Access Compliance Report

Public Rights-of-Way

(Curb Ramps)

Intersection ID: 15177	Main Street: CHARLOTTE_DR	Cross Street: E WORTHINGTON AV	Location: N
ADA ID: 579D0478240E	Ramp Type: PerpDiag	Initial Pass/Fail: Fail	Overall Compliance: No
Codes/Mitigation Info/Possible Solution		Field Measurements/Component Compliance

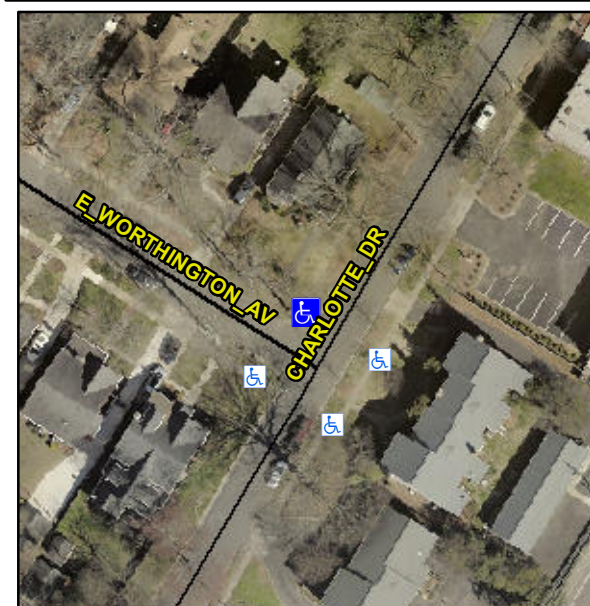
Not Found, R304.2.2, R304.5.3

Compliance	Description	Data	Compliance	Description	Data
N/A	Ramp Length (in)	101.0	No	Ramp Slope (%)	11.2
Yes	Ramp Width (in)	48.0	No	Ramp XSlope (%)	3.9
N/A	Flare Type LT	N/A	N/A	Flare Type RT	N/A
N/A	Flare Slope LT (%)	N/A	N/A	Flare Slope RT (%)	N/A
N/A	Flare Traversable LT?	N/A	N/A	Flare Traversable RT?	N/A
N/A	Landing Length (in)	N/A	N/A	DWS Provided?	N/A
N/A	Landing Width (in)	N/A	N/A	DWS Contrast?	N/A
N/A	Landing Slope (%)	N/A	N/A	DWS Length (in)	N/A
N/A	Landing X Slope (%)	N/A	N/A	DWS Full Width?	N/A
N/A	Landing Curb? (Y/N)	N/A	N/A	DWS Offset (in)	N/A
N/A	Shared Landing?	N/A			
N/A	Gutter Ponding?	N/A	N/A	Gutter Slope (%)	N/A
N/A	Gutter Lip Ht (in)	N/A	N/A	Gutter X Slope (%)	N/A
N/A	Painted X Walk1?	No	N/A	Painted X Walk2?	No
	X Walk 1 Direction	To SW		X Walk 2 Direction	To SE
N/A	X Walk 1 Width (in)	N/A	N/A	X Walk 2 Width (in)	N/A
	X Walk 1 Slope (%)	4.5		X Walk 2 Slope (%)	6.0
	X Walk 1 X Slope (%)	0.1		X Walk 2 X Slope (%)	1.9

Remove & Replace Curb Ramp With Two New Directional Ramps or Equivalent.
